Loopback

Loopback state diagram

- **Following slides show**
 - **Loopback state diagram**
 - **Parser action during each state**
 - **Observations about two approaches**
 - **Suggested pros/cons about each**
 - **Recommendation**
 - **Proposed change to Parser state diagram**

[D1.2] Fig 55-7 Loopback state diagram

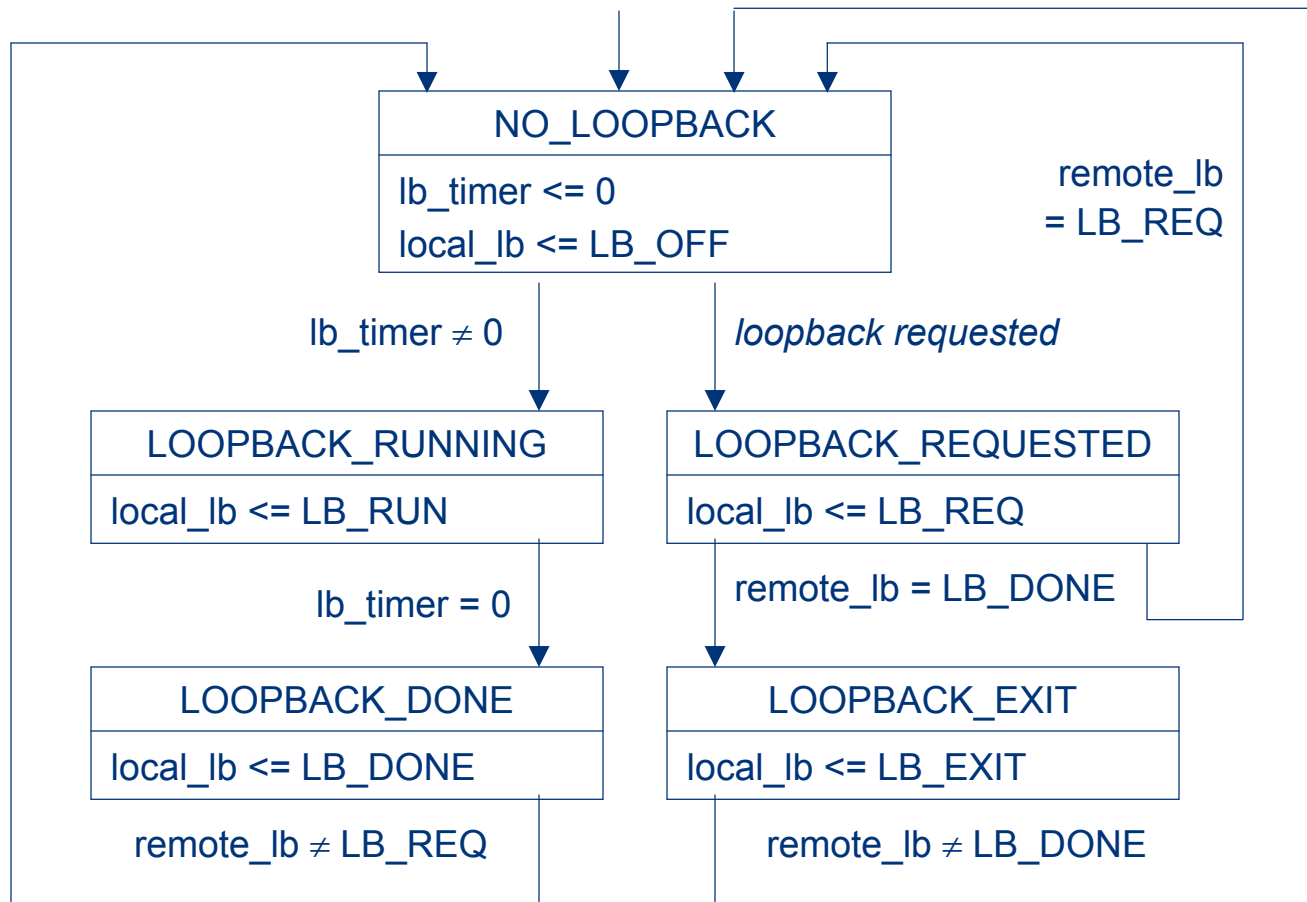
- **At least two approaches exist to implement/specify loopback**
 - **Have the OAM Client pass a parameter called “enable_remote_loopback” to OAM entity. OAM entity then manages the sending of Loopback Control OAMPDUs, the lb_timer, (near) simultaneous loopback requests, contain the state diagram etc.**
 - **Have the OAM Client contain the process to manage loopback and merely pass one parameter to the OAM entity: “parser_action” (forward, loopback, discard)**

- OAM client would then need to **transmit** and **receive** Loopback Control OAMPDUs (currently only Information OAMPDUs are transmitted by OAM entity, all OAMPDUs are passed to OAM Client for parsing)
- Synchronization between two state machines is complex

- **Move loopback process to OAM Client**
 - **OAM sublayer only performs Discovery**
 - **OAM sublayer only transmits Information OAMPDUs**
 - **All other OAMPDUs are transmitted by OAM Client**
 - **All OAMPDUs are passed to OAM Client for parsing**
 - **Parser state diagram amended (see next slide)**

[Proposed] Fig 55-5 Multiplexer

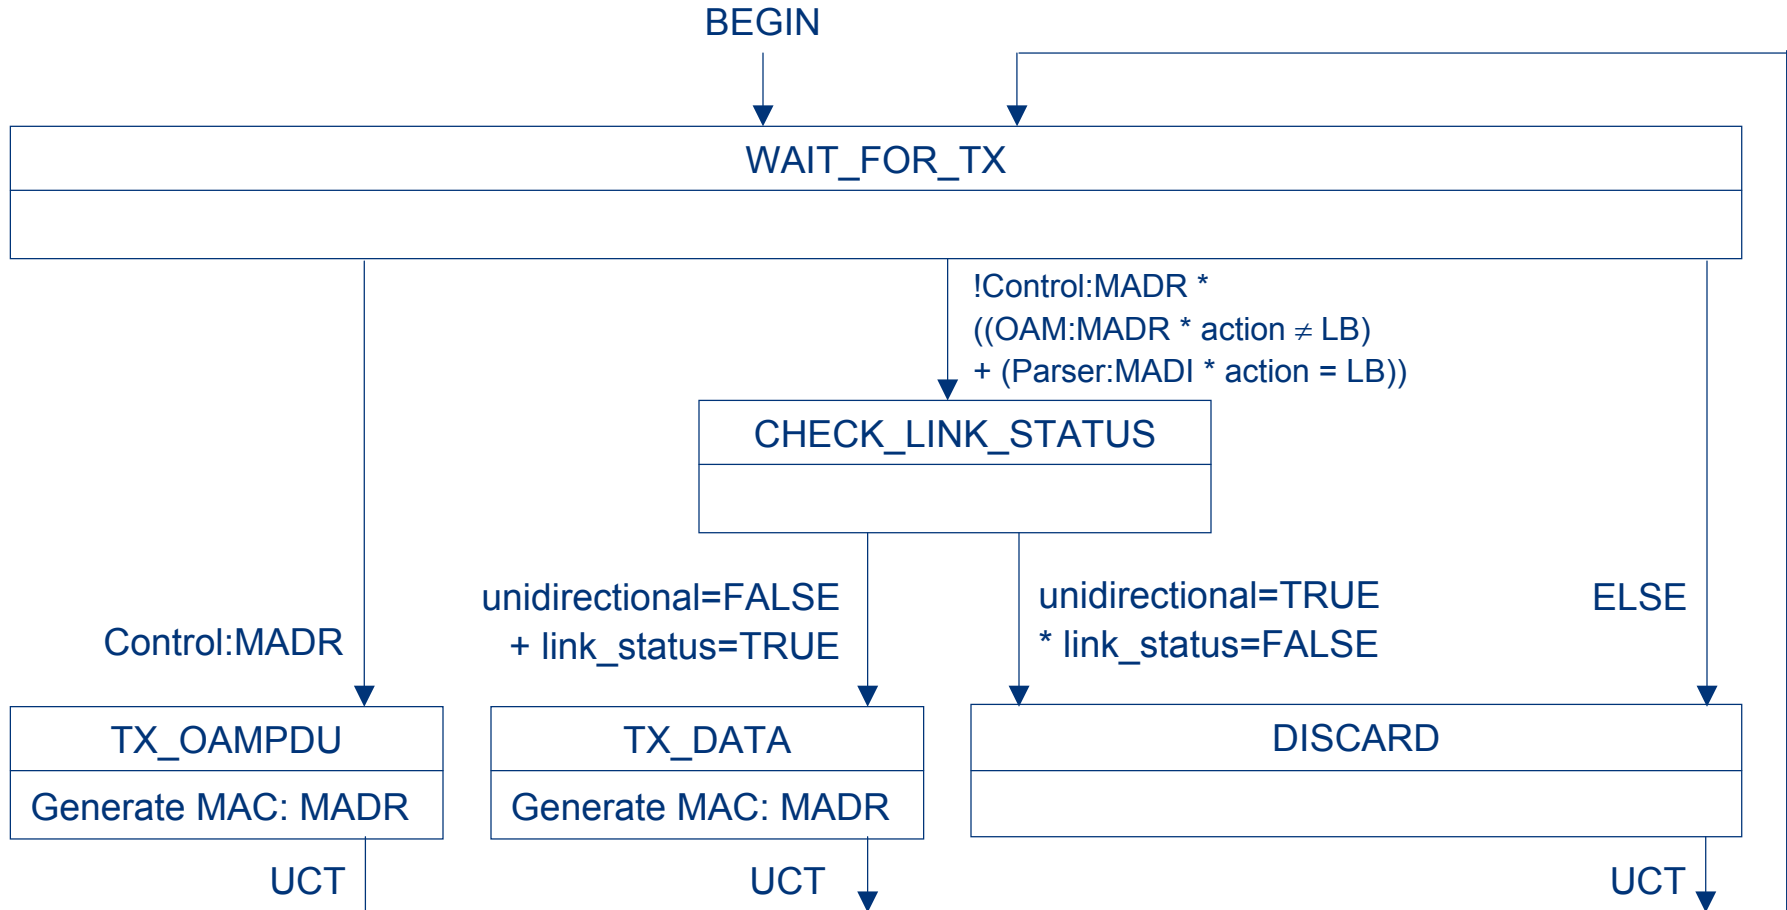
Tx OAMPDU given precedence whenever

Tx non-OAMPDUs when

Discard non-OAMPDUs when !link & uni

- Parser: add action parameter from OAM client
- Mux: add action parameter from OAM client
- LC OAMPDU definition
 - Data field structure
- Add state information in OAM_Information TLV (found in Information OAMPDUs) [lb_timer, action]

[Proposed] Fig 55-6 Parser

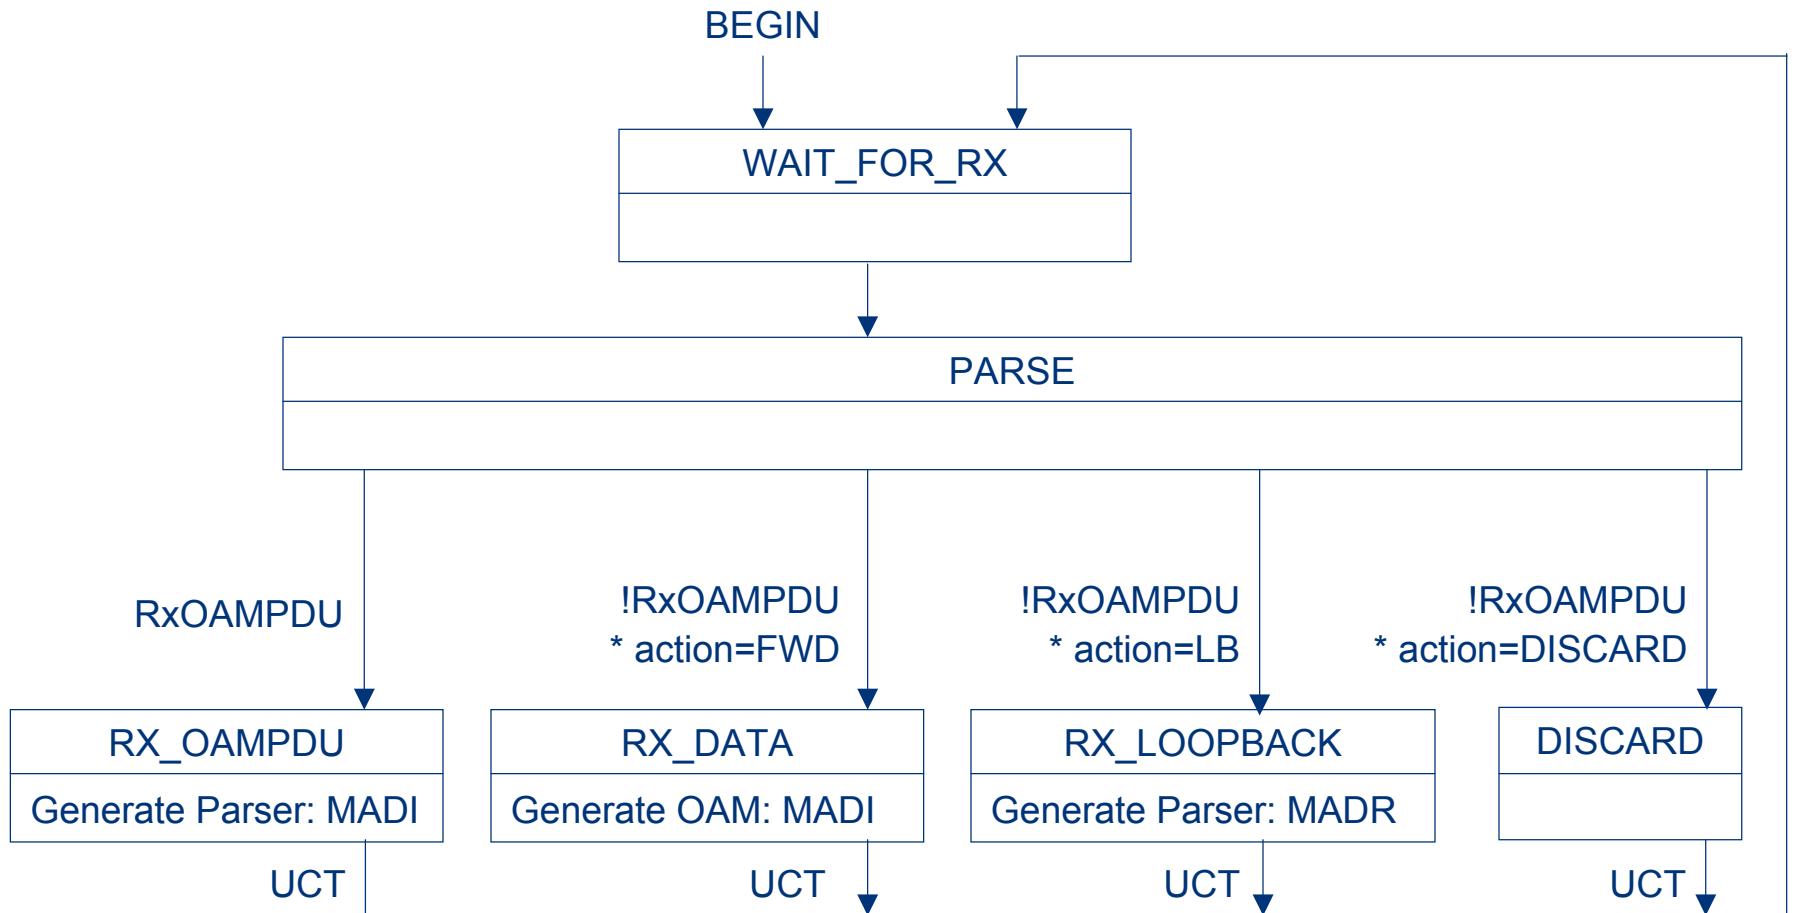
All OAMPDUs are **passed** to the OAM Client

OAM Client indicates when to **forward** non-OAMPDUs to MAC Client

OAM Client indicates when to **loopback** non-OAMPDUs to MAC Client

OAM Client indicates when to **discard** non-OAMPDUs
